CMOS IMAGER WITH INTEGRATED NON-VOLATILE MEMORY

Applicant: Christophe J. Chevallier
Serial No.: 09/136,680

Claims 1-28, as of December 11, 2002 (date of response to first office action filed).

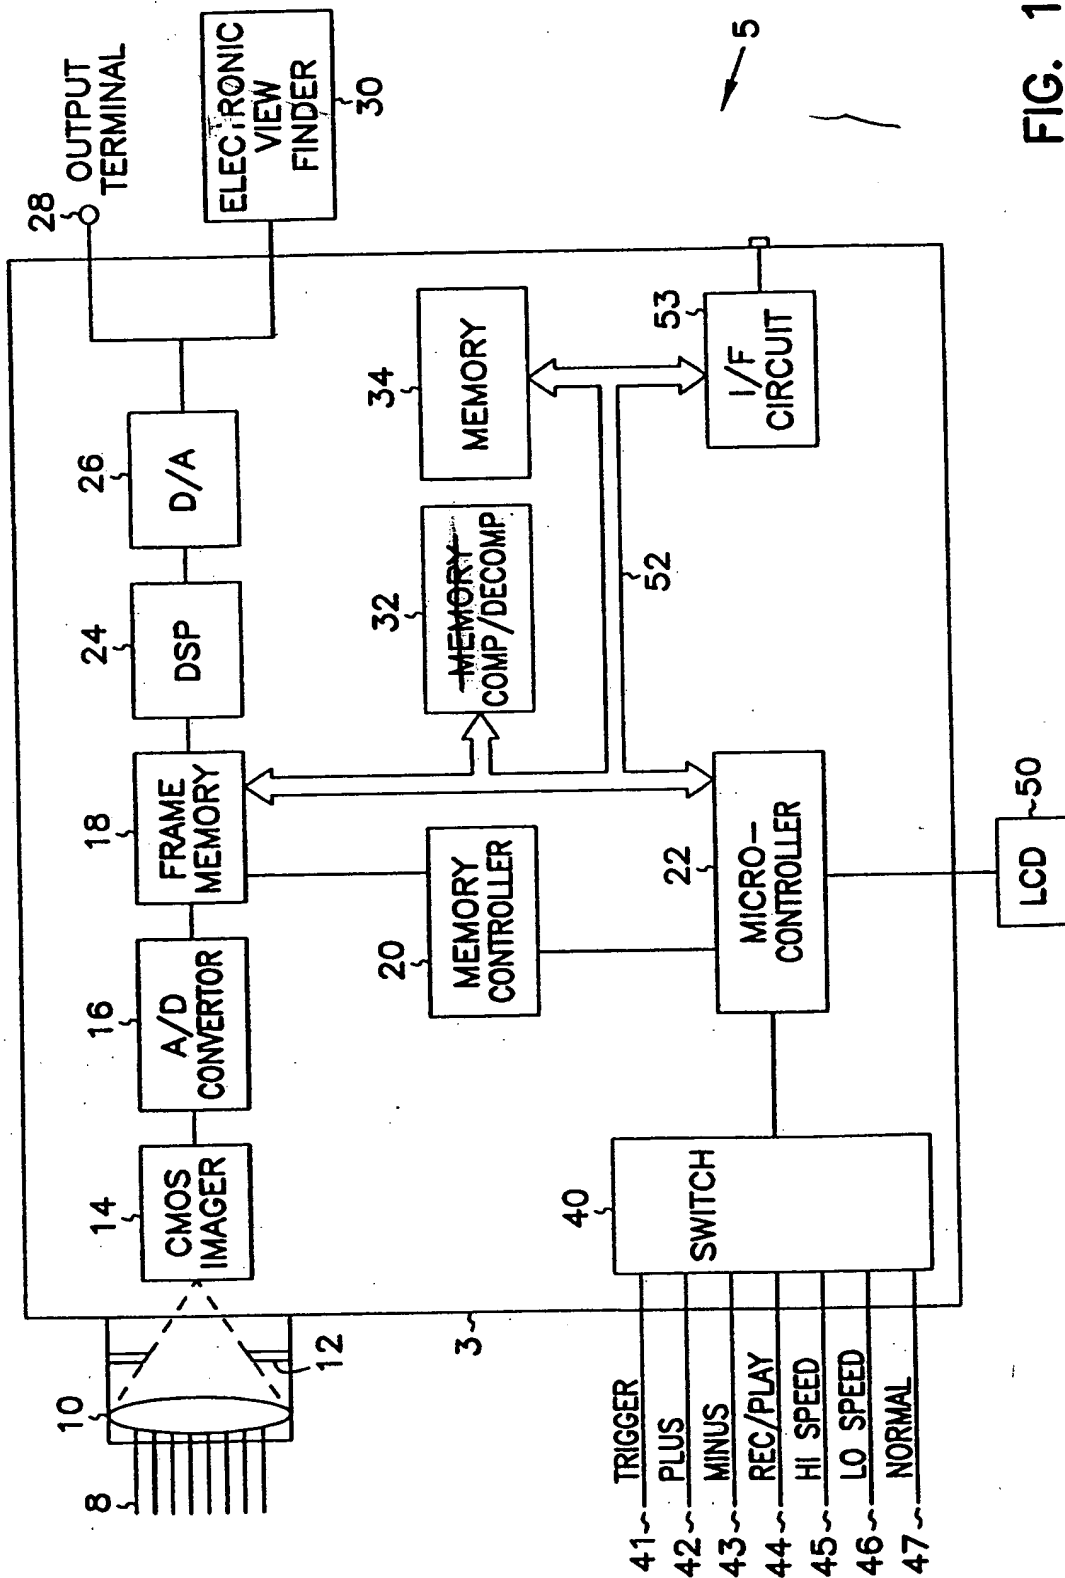
(a) In figure 1, element "memory comp/decomp 32: should be changed to --comp/decomp 32--; and (b) In figure 1, there is no connection between comp/decomp 32 and memory 34. It should include an arrow to indicate the compressed image data is fed to memory 34 as disclosed in the specification, page 6, line 20. Applicant proposes amending Fig. 1 to remove the term "memory" from comp/decomp 32 as suggested by the examiner. Approval of the proposed drawing amendment is requested.

With respect to the assertion (item "b" above), applicant respectfully traverses. Data bus 52 provides a connection between comp/decomp 32 and memory 34. See specification page 8, lines 4-5 and fig. 1. Withdrawal of the objection is requested.

Approved
2/19/03
LN

FIG. 3

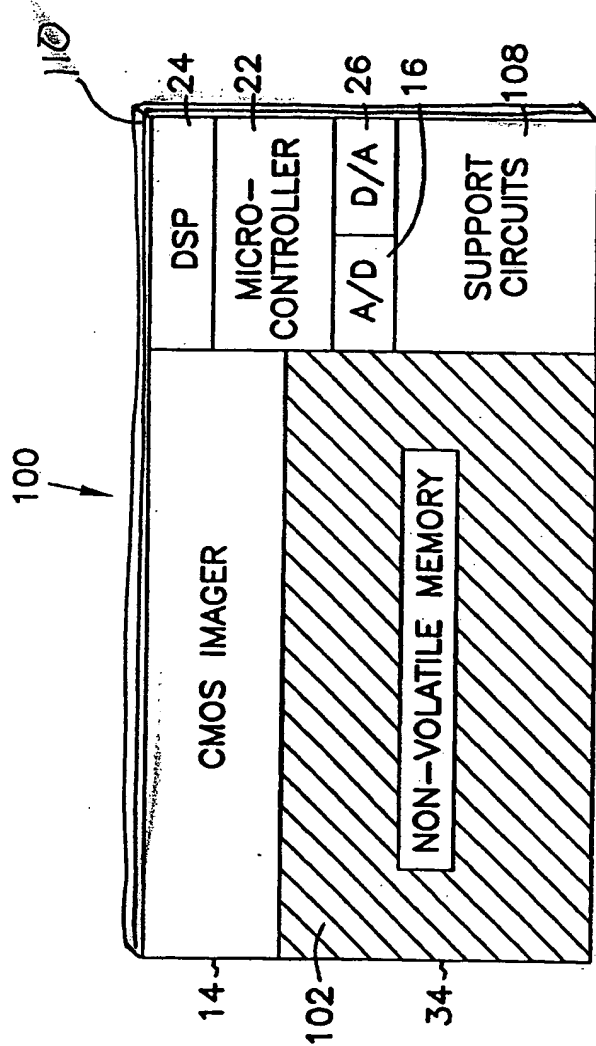
The disclosure is objected to because of the following informalities. In the specification, page 10, (lines 16, 28, and 29), page 11 (lines 2, 5-6, 8), all disclose "substrate 110." However, there is no disclosure of substrate 110 in figures 1-3. Applicant herein amends Figure 3 to include the substrate as described in the specification. It is believed that no new matter is proposed and the substrate is supported per 35 U.S.C. §112 in the specification. As the substrate is now included in Figure 3, withdrawal of the specification objection is requested.
